Contract Change Order # 1

Project Name: Rose District Mill and Overlay Project Number: ST1819
 Project Location: Downtown BA Date of Application: Tuesday, January 9, 2018
 Contractor: Ellsworth Construction, LLC. Submitted By: Nathan E.

Work Change Directive

Contract No. ST1819
Field Work Order No. #1
Project Number ST1819
Project Name Rose Dist. Mill & Overlay
Project Location Downtown BA

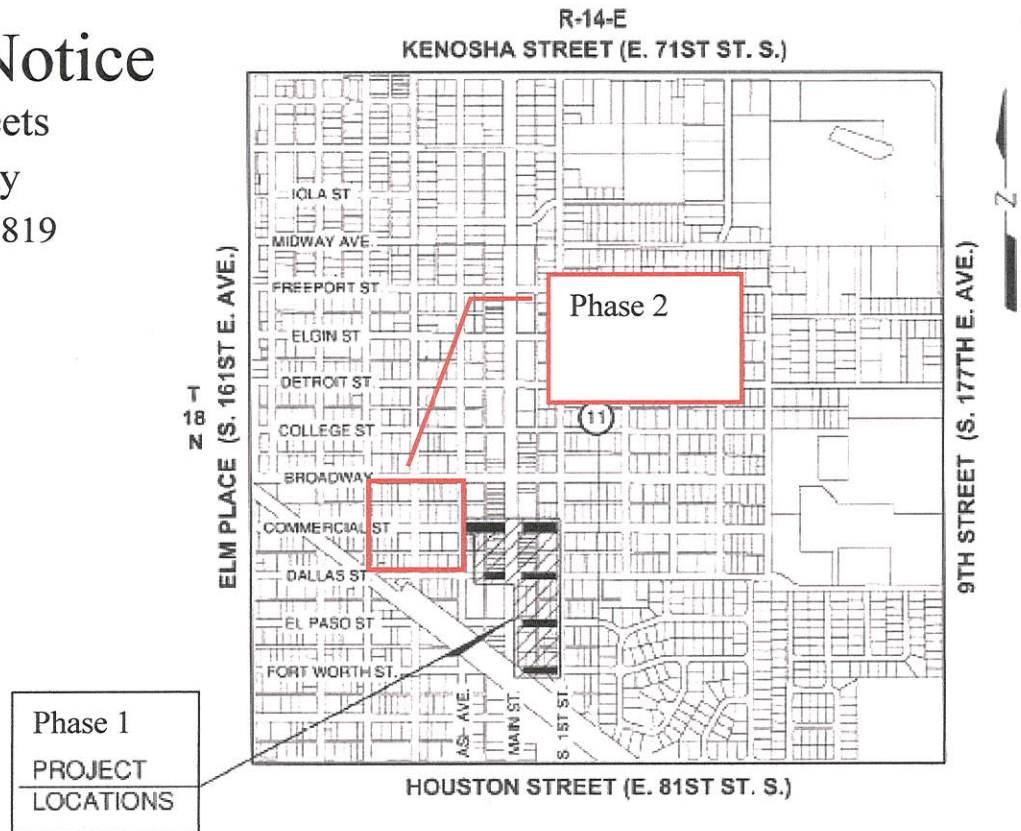
The project limits are to be extended to the streets of Commercial between Ash and Cedar as well as Birch between Dallas and Broadway (Commercial to Broadway along Birch to be determined in field). Commercial Street between Ash and Cedar is to be milled to existing concrete pavement and overlaid with S5 asphalt. Birch St. between Dallas and Commercial is to be milled 1.5 to 2 inches in depth (as field allowed) and overlaid with S5 asphalt. Birch St. between Commercial and Broadway shall have work directed in the field as funds are available. Patching is to be performed as required and authorized in the field by City CA. Standard details from original contract documents apply.
